Environmental testing - Part 2-69: Tests - Test Te/Tc: Solderability testing of electronic components and printed boards by the wetting balance (force measurement) method

EN 60068-2-69:2017/A1

AMENDMENT 1
AMENDEMENT 1

Figure 4 – Immersion conditions for solder globule method

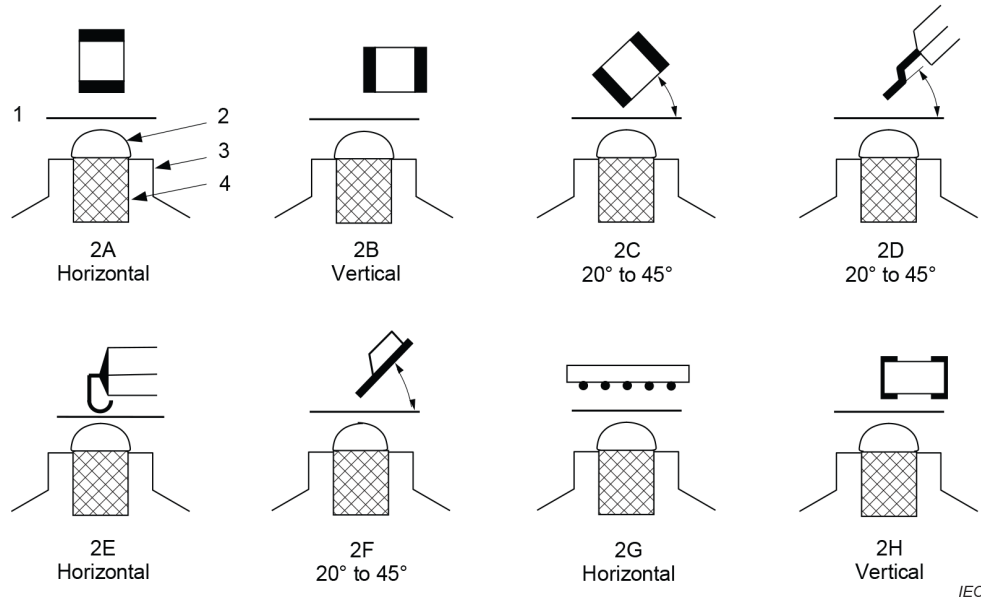
Replace Figure 4 with the following new figure:

**Key**

1	Horizontal line	2	Solder globule
3	Globule support block	4	Iron pin

Figure 5 – Suggested wetting balance test specimens for printed boards

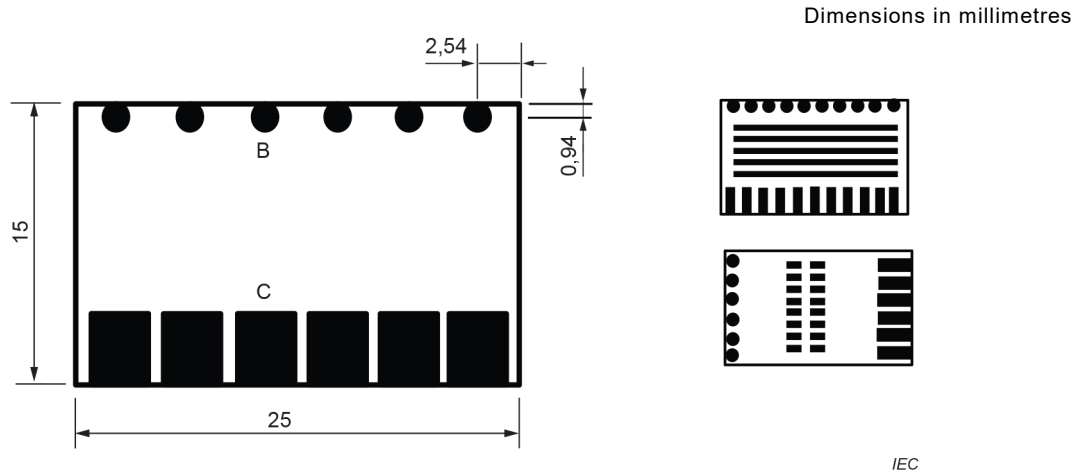
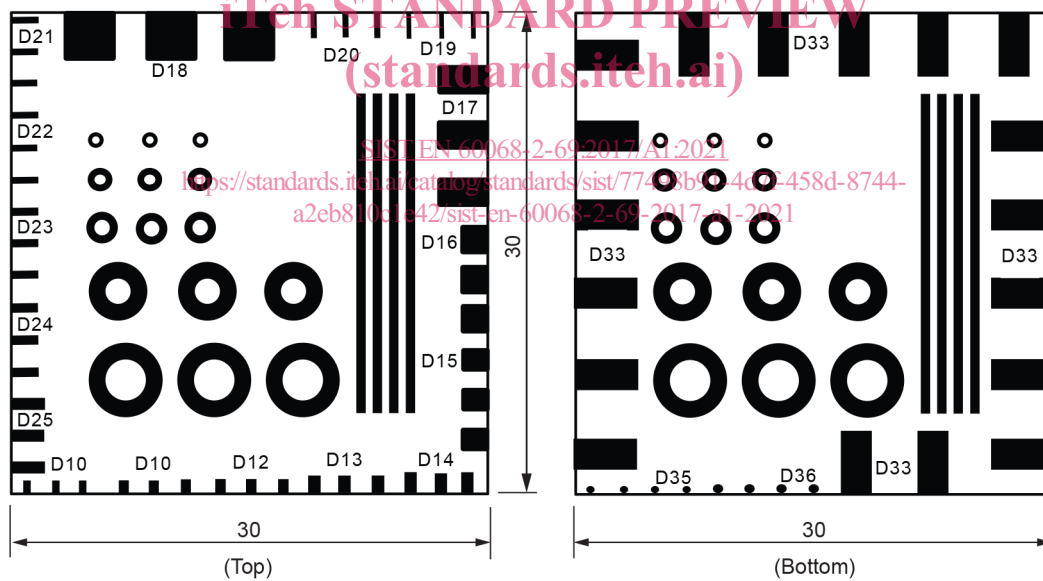
Replace Figure 5 with the following new figure:

NOTE The figures on the right-hand side show the alternative configurations.

a) Test specimen for solder bath method

b) Test specimen for solder globule method
